# UNITED STATES PATENT AND TRADEMARK OFFICE

APPLICATION NO.	FILING DATE	FIRST NAMED INVENTOR	ATTORNEY DOCKET NO.	CONFIRMATION NO.
10/534,436	12/13/2005	Satoshi Takamori	04473/003001	4509

# Office Action Summary

## **DETAILED ACTION**

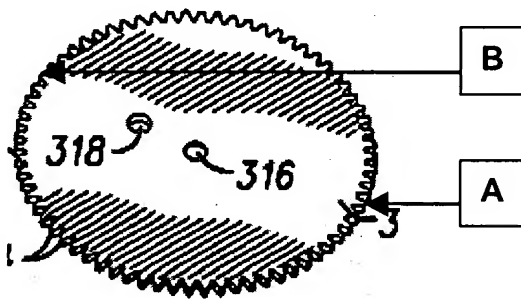
an eccentric cam **318,310** rotating eccentrically with respect to the planar direction, the eccentric cam having a portion **A** (Figure 3 reprinted below with annotations) corresponding to the closed position at one rotational position with maximum eccentricity on a cam surface (maximum eccentricity being defined by a maximum distance from camming point **318**) and a portion **B** corresponding to the open position at another position with minimum eccentricity on the cam surface (minimum eccentricity being defined by a minimum distance from camming point **318**), the positions being 180 degrees opposite to each other; and

a pressing means **140,320,330**, which presses the cam surface of the eccentric cam by setting a pressing direction to the same direction as that of a line connecting both of the portion corresponding to the closed position and the portion corresponding to the open position, the portions being 180 degrees opposite to each other through the axis of the eccentric cam, wherein a pressing load is applied to the cam surface, rotation control over the eccentric cam being increased to stop rotational movement of the eccentric cam when the pressing means engages the portion corresponding to the

As to claim 2, Godston et al. disclose a mechanism wherein, when the portion **B** corresponding to the open position on the cam surface of the eccentric cam **318,310** engages the pressing means **140,320,330**, a control means **129** for controlling excessive rotation beyond the position corresponding to the open position in the same direction as that in which the eccentric cam is rotated 180 degrees to the open direction is provided (Figures 3-5).

As to claim 3, Godston et al. disclose a mechanism wherein the eccentric cam **318,310** has a recess (defined between adjacent teeth **314**) corresponding to the closed position at one point **A** with maximum eccentricity on the eccentrically rotating cam surface, to which a protruding portion **142** of the pressing means **140,320,330** engages,

and has a recess (defined between adjacent teeth **314**) corresponding to the open position at one point **B** with minimum eccentricity, to which the protruding portion **144** of the pressing means engages (Figures 3-6).
